**ADDENDUM NUMBER: TWO**

**ISSUED BY: SEPW Architecture Inc.**  
109 – 3725 Pasqua St., Regina, SK. S4S 6W8  
PH. (306) 569-2255

**PROJECT: RCMP RTM TRANSPORT STAFF BUILDING,  
REGINA, SK.**

**A-2-4 REF. DRAWING E0, ELECTRICAL, SITE PLAN**

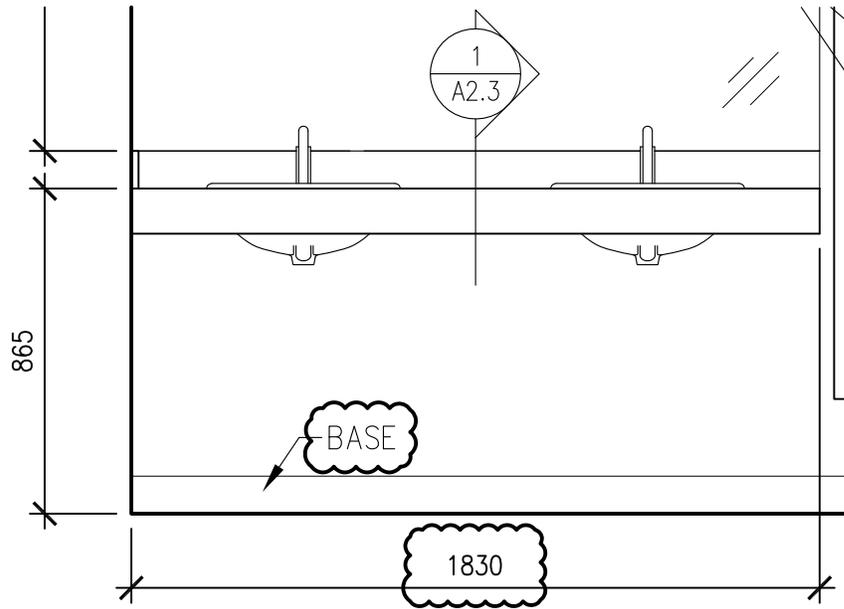
.1 Add the following: “Electrical contractor shall provide new plywood backboard for exterior electrical distribution.”

- .2 Add the following: "Electrical contractor shall replace existing 208V, 225A, 3p, 4W splitter trough with new splitter with the same electrical characteristics."

**2**  
AR-3 ROOM 102 MILLWORK  
1:30

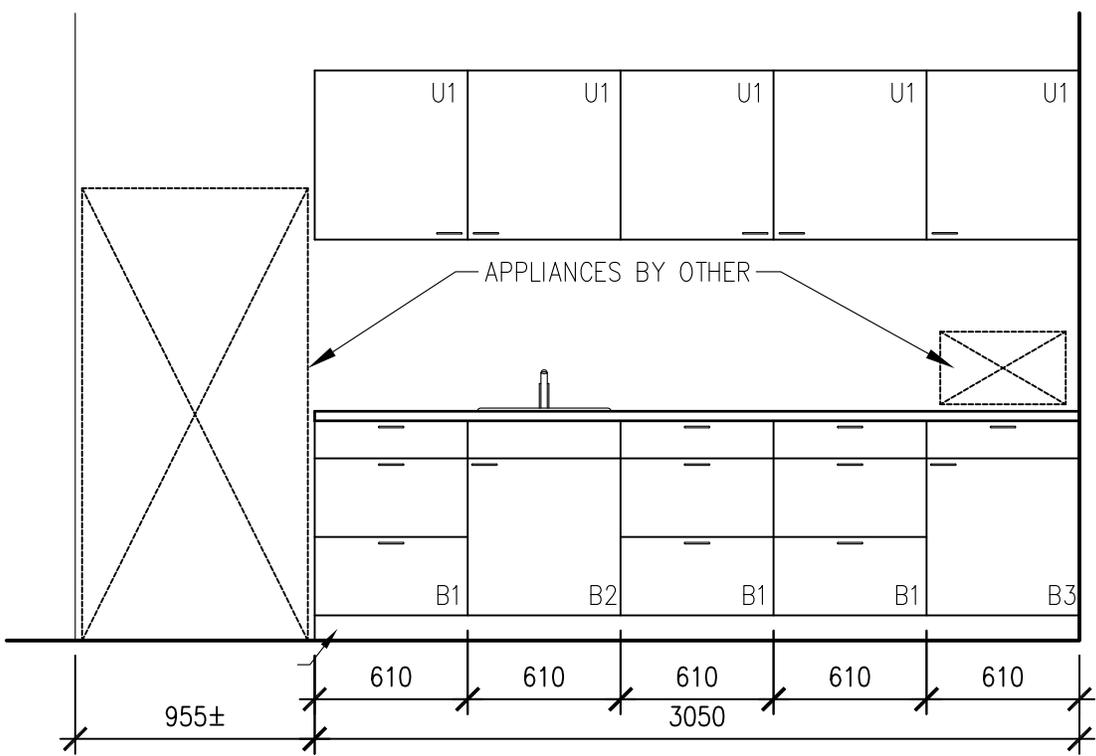
.1 Reference detail 2, Room 102 South Millwork: Revise upper millwork to run across entire length of cabinets as shown in the interior elevation. Refer to drawing A2.2, detail 4.

.1 Reference detail 2: Revise Interior elevation as per drawing AR-3 attached to this addendum.

.2 Reference detail 4: Revise Interior elevation as per drawing AR-3 attached to this addendum.
